North American Electric Reliability Corporation	**)** **)**	**Docket No. RM13-_____**

PETITION OF THE NORTH AMERICAN ELECTRIC RELIABILITY CORPORATION FOR APPROVAL OF PROPOSED RELIABILITY STANDARD PRC-005-2 (PROTECTION SYSTEM MAINTENANCE)

February 26, 2013

Figure 2: Typical Generation System

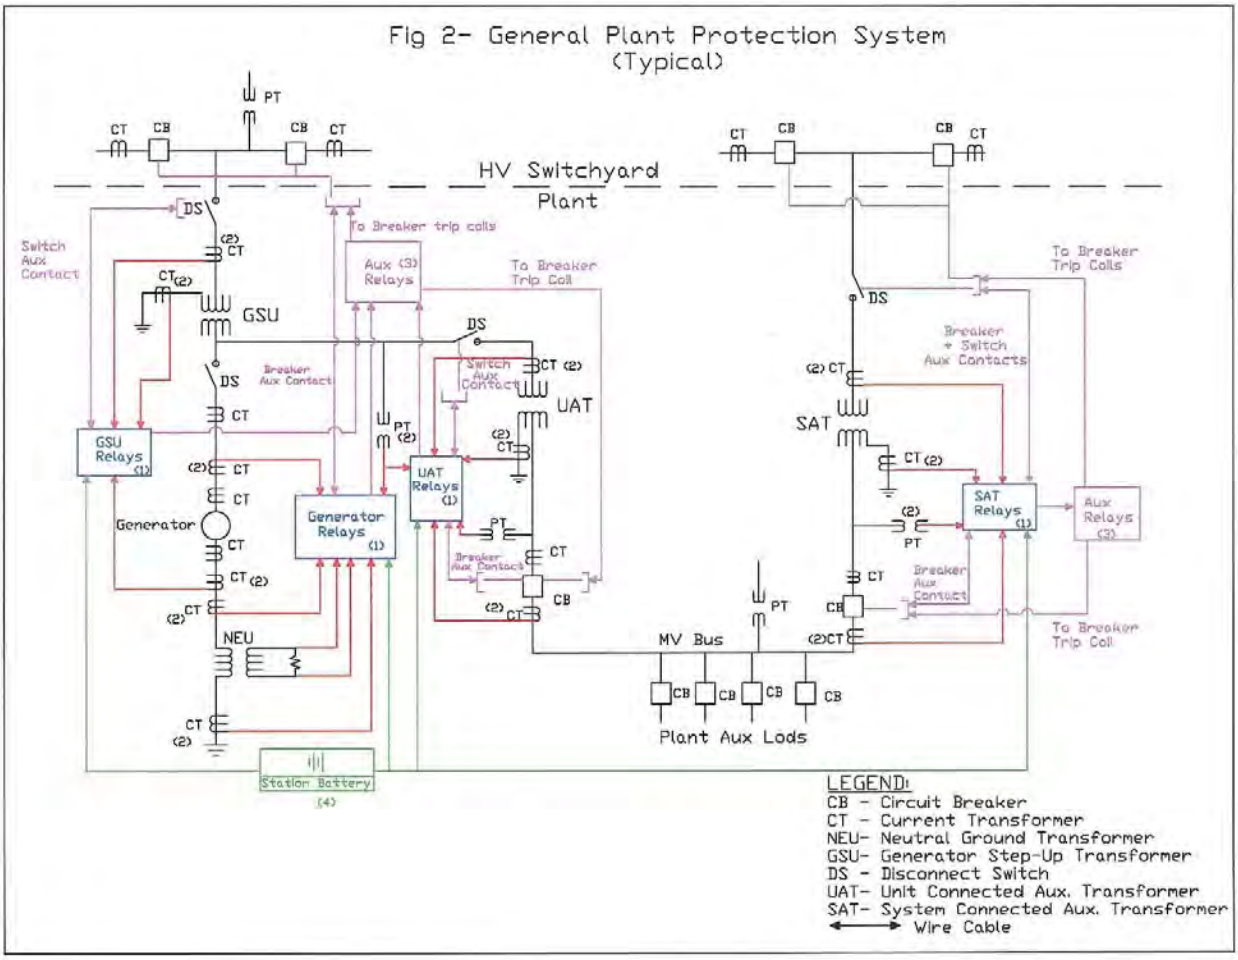
Organization	Yes or No	Question 5 Comment
Public Service Enterprise Group ("PSEG Companies")	No	1. Suggest that figure 2 has a line of demarcation added that shows components specifically not part of the standard requirements. (Medium voltage bus). 2. Battery charger should be removed from table of components when a storage battery is used for the DC supply.

Organization	Yes or No	Question 3 Comment
Florida Municipal Power Agency	Yes	
PSEG Companies ("Public Service Enterprise Group Companies")	Yes	Figure 2 "typical generation system" shows a typical auxiliary medium voltage bus, in addition to the color coded elements suggest that a very distinct line of demarcation (dark dotted line) be added to the figure that defines the elements associated with the MV bus protection served by the station Aux Transformer and unit aux transformer are not part of the BES- PSMP PRC5 requirements. Also see comment 5 below; we suggest that the station service transformer must be connected to BES for inclusion in standard requirements. Suggest adding an explanation note to figure 2 to clarify this.

Response: Thank you for your comments. Figure 2 is intended to provide an example to users, not to describe the entire applicability of the draft standard. As such, the SDT does not believe that this figure needs to reflect all possible arrangements, nor does it need to suffice to describe the entire applicability. As for your comment regarding the unit auxiliary transformer, please see the SDT response to your more detailed comments in Question 5.		
MRO's NERC Standards Review Subcommittee	No	
Western Area Power Administration	No	
TransAlta Centralia Generation Partnership	No	
NextEra Energy	No	
City of Austin DBA Austin Energy		
PacifiCorp		
Southern Company Transmission	Yes	1. Page 11 and 12, (Additional Notes for Table 1-1 through 1-5) Comment ->> The standard does not reference these notes. Should these notes be referenced and included in the Standard? 2. Page 12, Additional Notes for Table 1, item #7 ("performing an operational trip test")
